STAFF RECOMMENDATION

NCPC File No. 6762

**NEBRASKA AVENUE COMPLEX
CAMPUS SECURITY UPGRADES**
Nebraska Avenue, NW at Massachusetts Avenue, NW
Washington, D.C.

July 26, 2007

(Main) Nebraska Avenue Entry (North)

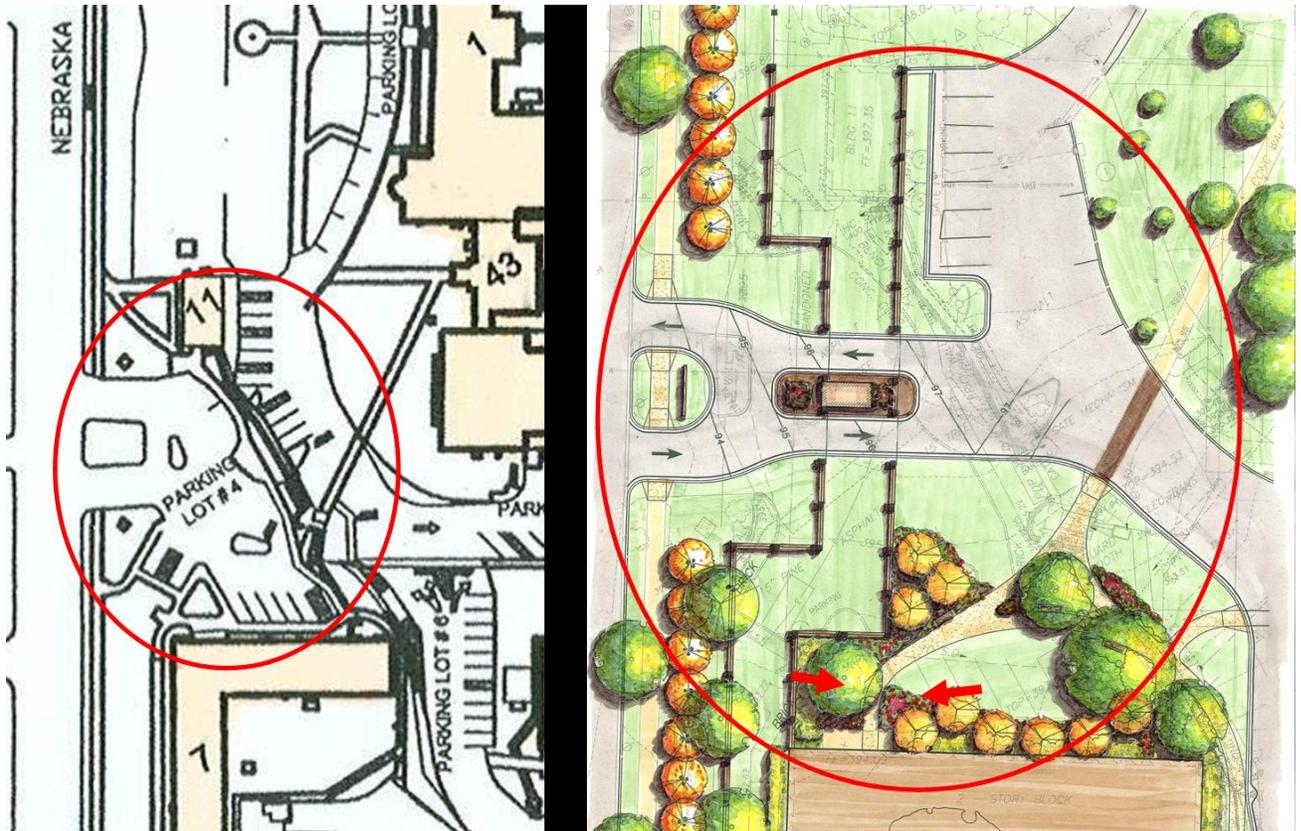
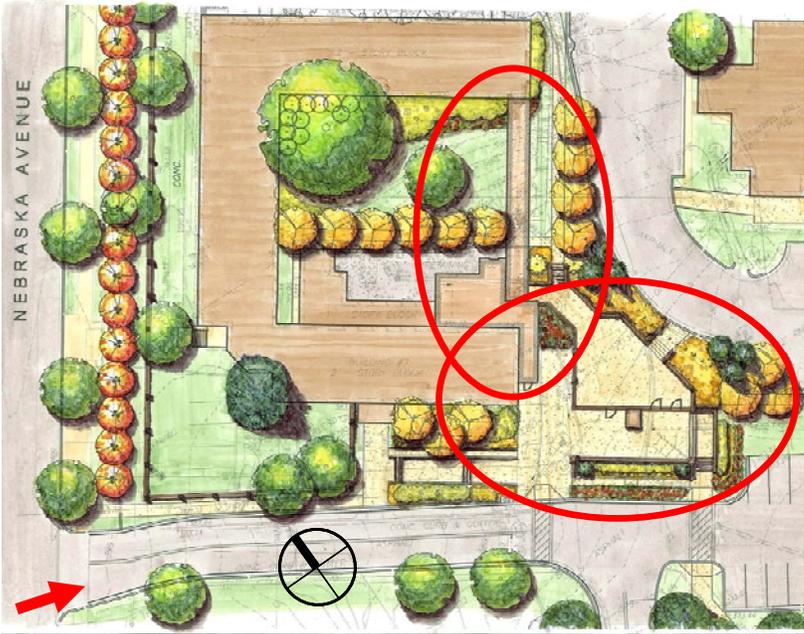
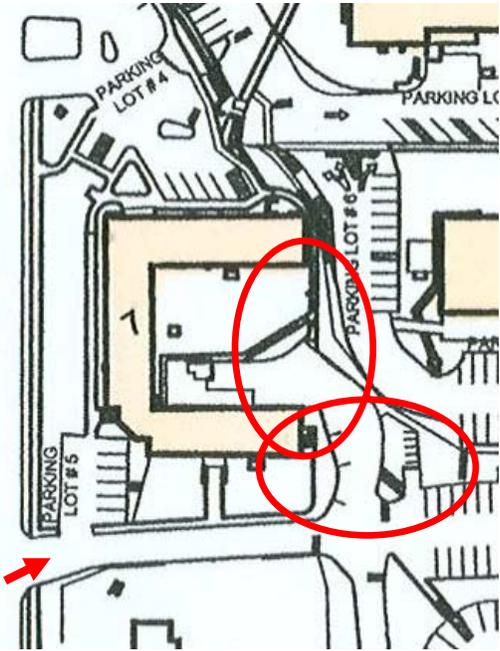
The applicant has indicated that the project will improve the circulation at entrances and throughout the campus. Streamlining both vehicle and pedestrian circulation (roads, sidewalks and plazas), and earmarking various entry points for use by various types of users will improve its legibility. The main (north) entrance on Nebraska will no longer be cluttered by various users or by unclear circulation such as shuttle buses that must turn around. A new traffic island will streamline one-way traffic on either side. In addition, its users will be streamlined to VIPs and emergency vehicles only. Staff supports the conversion of miscellaneous parking lots, as well as Building 11 to be demolished, into green space and plaza, which will also increase the buffer space between double fence lines. The submission includes insufficient information on wayfinding signs and shuttle bus movements. The applicant must submit this information at the preliminary submission stage.

- Submit visual simulations or renderings as well as technical information expressed in lumens to demonstrate any lighting spill-over beyond the property line.
- Show shuttle bus routes, wayfinding signs, and drop-off locations as well as an overall vehicle circulation plan sufficient to clarify the intention and to demonstrate that shifting shuttle bus drop-off points will not adversely impact Ward Circle or the traffic pattern.

Building 7: Proposed Entry / Bridge Elevation (Southeast)

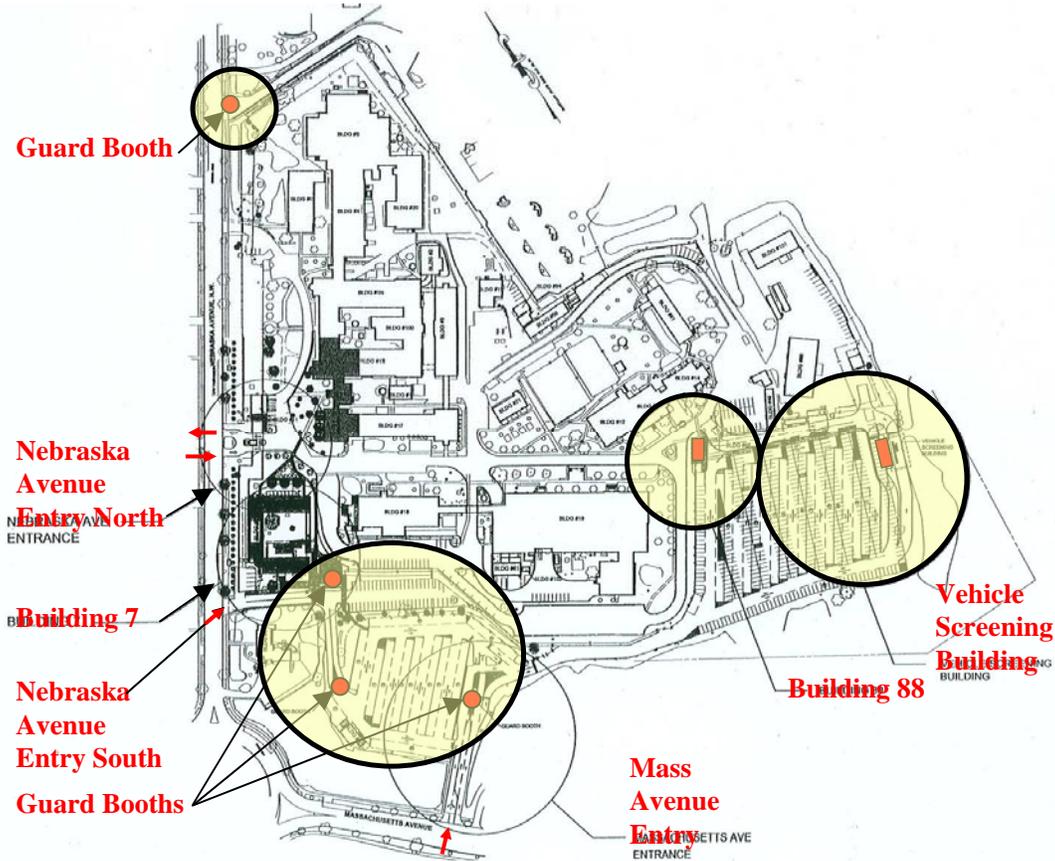
Staff views the proposed design for additions and exterior renovations to or Building 7 as appropriate for the purpose and function the building will serve, and reiterates support for converting cluttered asphalt parking areas to a plaza that would serve as queuing space for visitor badging and have a green planted edge, as well as green space with new trees.

Proposed Guard Booths

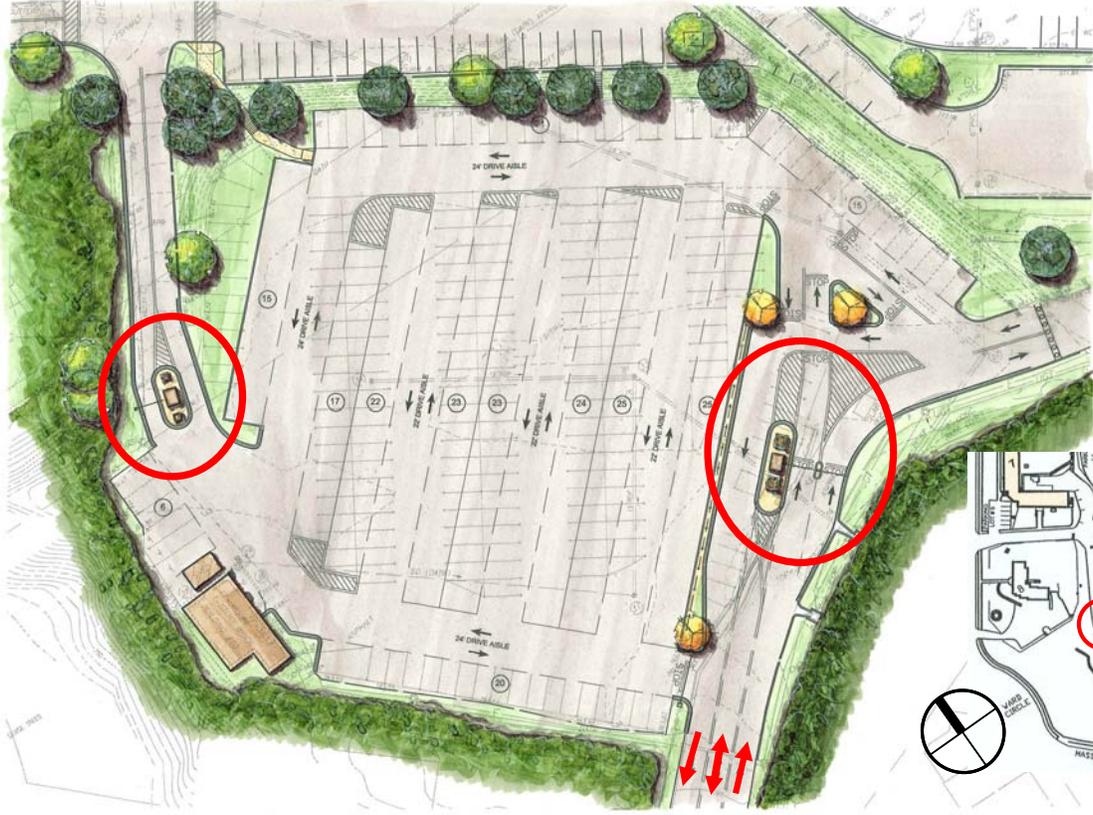
The design for the prefabricated guard booths has not been included with the concept submittal. Staff expects to review designs including facade materials and heights as well as information about lighting levels at the fence line included with the next submittal. Staff would support the use of as much additional planting around the guard booths as possible to soften these areas, as well as to screen the edges of parking lot areas.

Proposed Screening Buildings

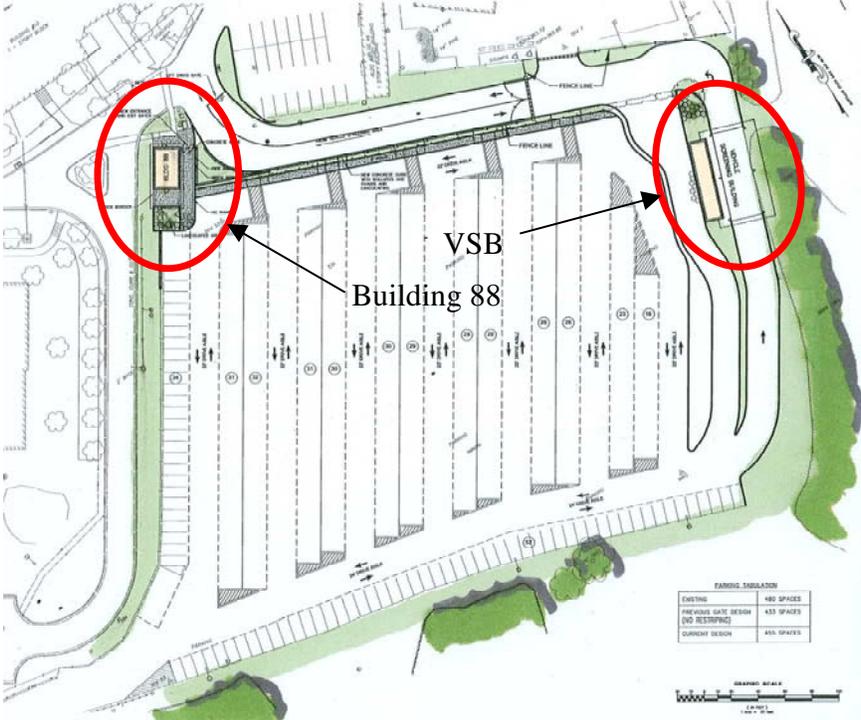
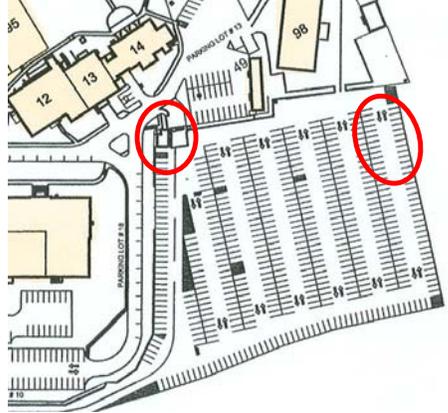
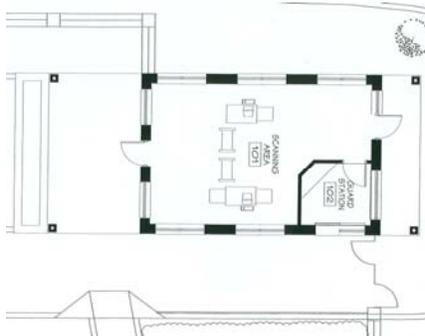
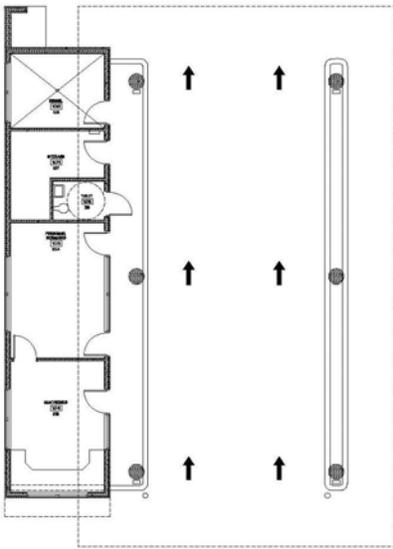
Staff views the proposed designs for both buildings as appropriate to each context. Building 88, closer to the brick structures on the campus, has taken its cues from those buildings. The façade of the VSB will relate to the new façade on Building 7, also metal and glass. As the pedestrian and vehicular entrances into the NAC, the use of similar materials and detailing will reflect a uniformly “hi-tech” image upon entering the DHS campus. Staff would support the use of as much additional planting at parking lot edges as possible to soften and screen these areas.
